PROPOSED SUBWAY IN
 TWENTIETH STREET
 UNDER M.C.R.R.

M. C. R. R. 20TH ST. YARD

LONGITUDINAL SECTION
 HOR. SCALE ONE INCH = 40 FEET
 VER. " " = 10 "

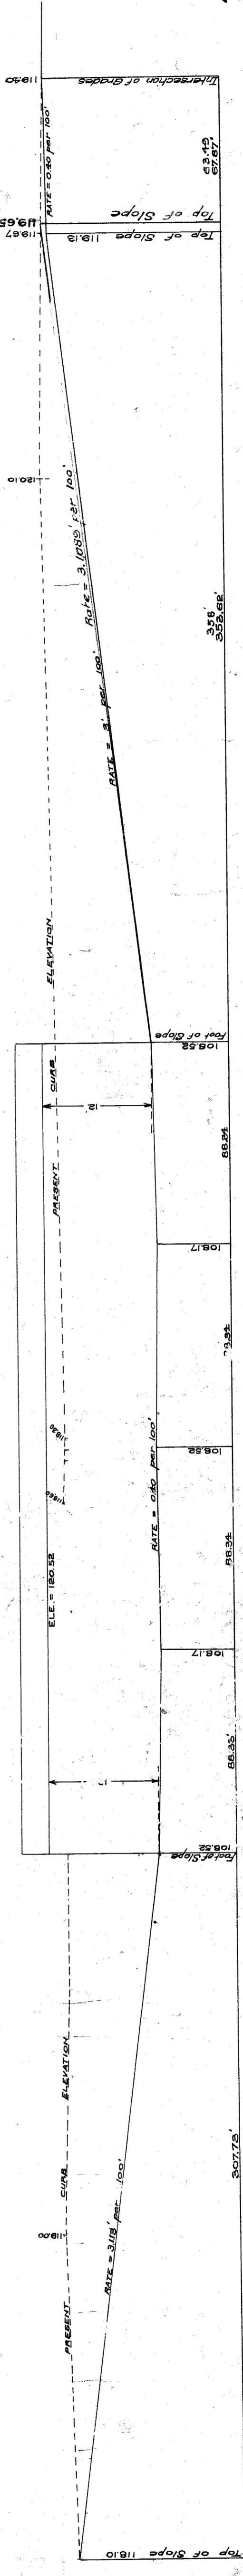
Aug. 1910
 Change of Grade made necessary
 by reason of relocating of track across
 20th Street entering Viger Coal Co's.
 Property & D. P. W. Storage Yard. See
 Council Pro. of July 25/10.
 J.M.R.
